OPTIMIZATION EVALUATION

PALERMO WELLFIELD SUPERFUND SITE CITY OF TUMWATER, THURSTON COUNTY, WASHINGTON

Report of the Optimization Evaluation Site Visit Conducted at the Palermo Wellfield Superfund Site August 25, 2011

November 30, 2011

MW-ES-09
TCE Concentration Time-Trend Plot

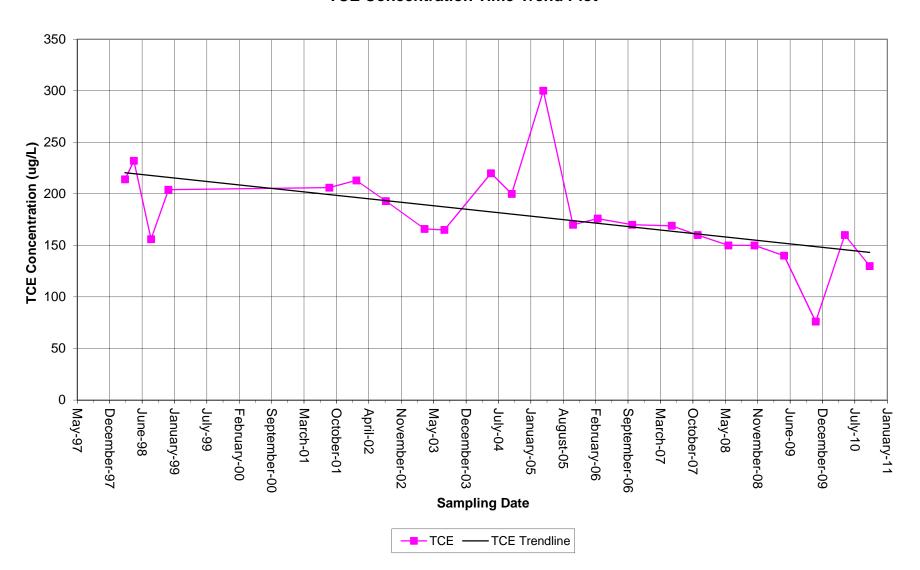
TCE concentrations at MW-ES-09 are currently the highest observed TCE concentrations at the site and concentrations are declining slowly, indicating it will take many decades to reach MCLs in this area with the current remedial approach, even if upland sources have been removed. In addition, the higher concentrations at shallower depths (compared to wellfield pumping at deeper depths) and the position of the Palermo Wellfield south of the plume core increases likelihood that the wellfield may not provide full capture (plume capture is further discussed in Section 5.2.2).
